**Stress as a Function of the Block Orientation**

Ang Lee  
 April 25, 2011

In the pivoter review committee summery (Nova-doc-5775-v1, March 30, 2011), the following questions have been raised as :

**Fig 1 Stress as function of rotation Angle**

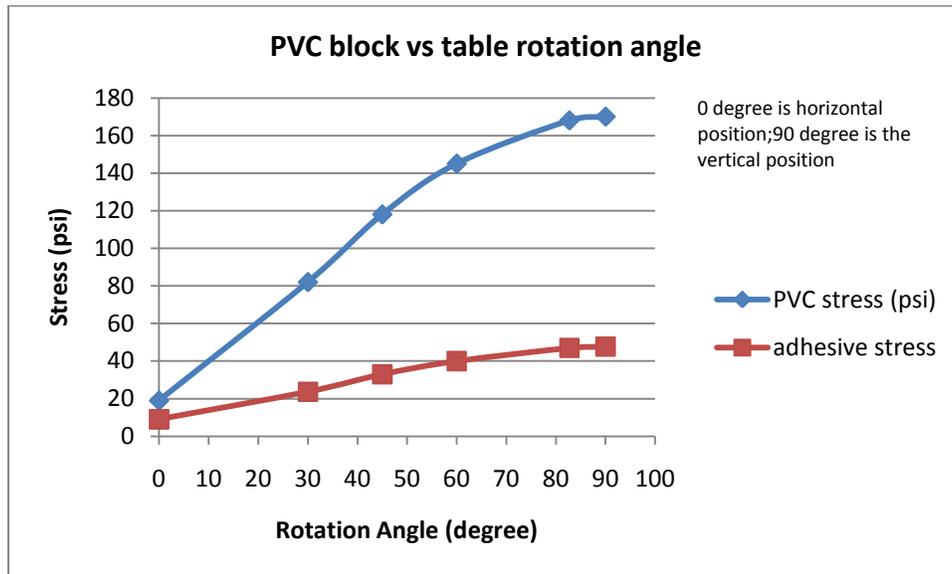
*&1.2 There was no reference to any stress analysis of a block in all orientations of the pivoter when going from the assembly phase (flat) to the installation phase (vertical, and in particular tilted back on the table during the movement to the installation location). Are there configurations during the rotation that cause high stress to the block as the load transfers from the table to the pallet?*

*&4.2 There is a concern for potential to damage the corner of the blocks when they arerotated to the vertical position for installation.*

For an unfilled case, the above structure only contains a load condition of (a)\_ PVC weight, which will be less severe than a fully loaded case. To response committee concern quantitatively, we have rotated a dry structure at 0 (horizontal), 30, 45, 60 and 90 degree (vertical). Both PVC and adhesive stress are extracted and plotted against the rotation angle as shown in Fig 1.

- 1) The result indicates that both maximum, PVC and adhesive, occurs at the vertical position (90 degree). The PVC stress is less than 180 psi and ~50 psi for the adhesive shear, respectively. It is considered to be minimum as expected.

- 2) Plot in Fig 1 contains an additional data point at angle= $\sim 82.7$  degree where the block corner being lined up with the gravity center. There is no evidence, strictly from the calculation, showing any additional stress. However, a further attention is warranted for the FHEP table/block test since only the field test result can truly answer this question.
